ECE/TRANS/WP.29/GRSG/2009/18
10 August 2009

REGULATION No. 73
(Lateral protection devices)

Proposal for draft amendments to Regulation No. 73

Submitted by the expert from the International Association of the Body and Trailer Building
Industry */

Model A
(see paragraphs 5.1.4. and 5.3.4. of this Regulation)

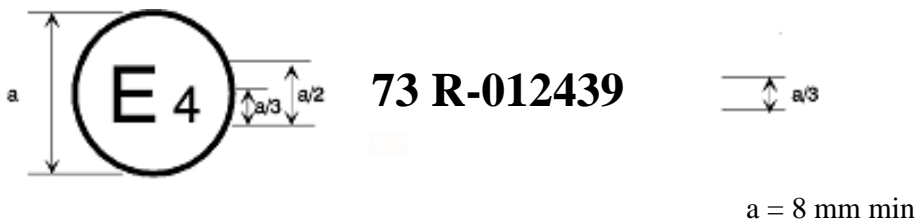
The above approval mark affixed to a vehicle **or to an LPD** shows that the vehicle type concerned has, with regard to its lateral protection, been approved in the Netherlands (E 4) pursuant to Regulation No. 73 under approval number **012439 as a complete vehicle**. The first two digits of the approval number indicate that the approval was granted in accordance with the requirements of Regulation No. 73 **as amended by the 01 series of amendments**.

Model C
(see paragraphs 5.1.5. and 5.3.5. of this Regulation)

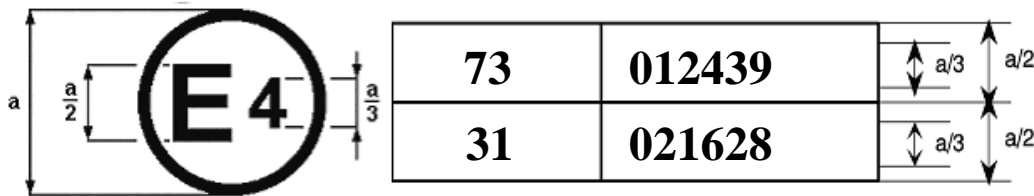
The above approval mark affixed to a vehicle shows that the vehicle type concerned has been approved in the Netherlands (E 4) pursuant to Regulations Nos. 73 and 31 1/. The first two digits of the approval numbers indicate that, at the dates when the respective approvals were granted, Regulation No. 73 **included the 01 series of amendments and the approval was granted for a completed vehicle**, and Regulation No. 31 **included the 02 series of amendments**.
